Committee: Strategic	Date: 11 January 2018	Classification: Unrestricted	Agenda Item Number:
--------------------------------	---------------------------------	----------------------------------------	----------------------------

Report of: Director of Place	Title: Application for Planning Permission
Case Officer: Elizabeth Donnelly	Ref No: PA/17/02217 - Full Planning Permission
	Ward: Whitechapel

Location: Land and Fieldgate Street and Whitechapel Road, Fieldgate Street, London.

Proposal: Demolition of existing substation and construction of a 20 storey building, including 11,450 sqm of student accommodation totalling 375 rooms; 1,050 sqm of office (B1a) floorspace at ground/first floor level ;70 sqm of commercial floorspace (A3 use) at ground floor level; basement and new pedestrian link to the eastern boundary of the site.

Figure 1.1: The proposed building in its immediate context

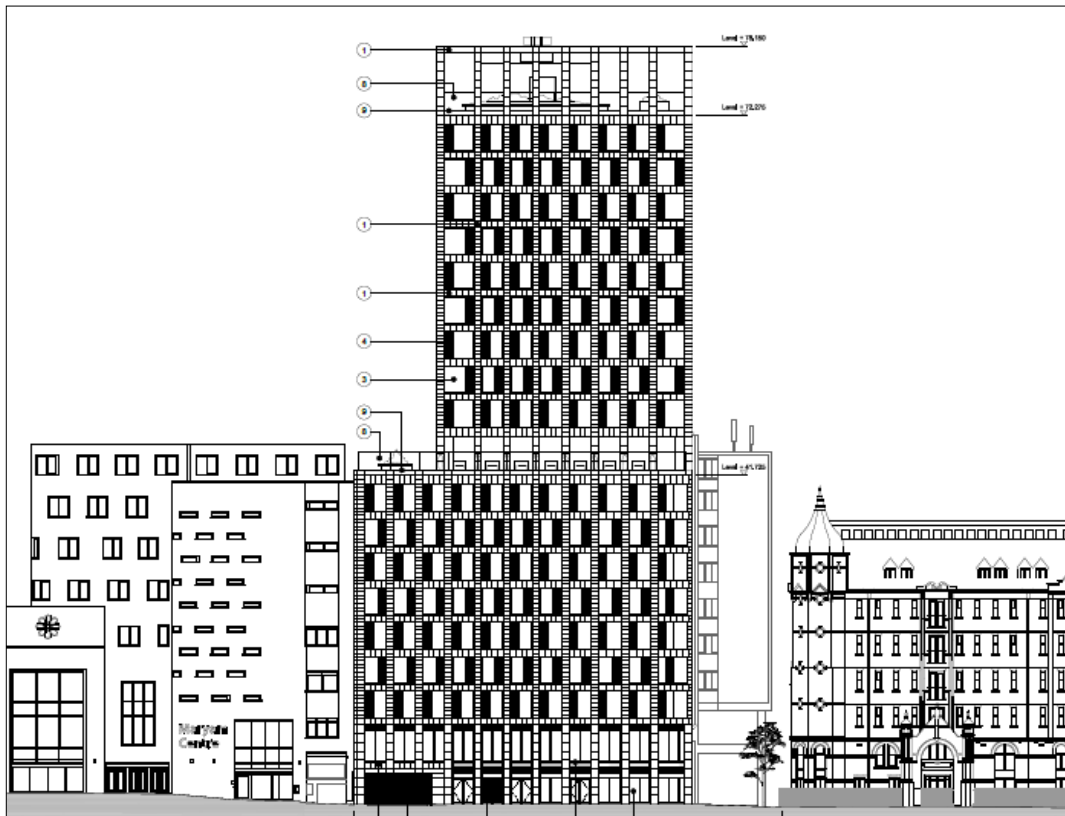
- 2.6. The height, scale and massing of the proposed 20 storey development is objectionable. The proposal is significantly disproportionate to the scale of its surroundings, including the adjoining Myrdle Street Conservation Area. It is not considered that the application site can support a building of the proposed scale. The proposal would result in harm to the Myrdle Street Conservation Area, as well as a significant impact upon the character and appearance of the wider townscape. It is not considered that any of the perceived benefits associated with the scheme would outweigh this impact.

- 4.13. The building includes a crown of 5.4m, behind which a stair enclosure and lift overrun that project to a maximum of 3.8m above roof level would be located. A BMU (Building Maintenance Unit) would also be located at roof level and project a further 2.3m above the lift overrun. The proposed scale and massing is illustrated in Figure 1.1 and 1.2 below.
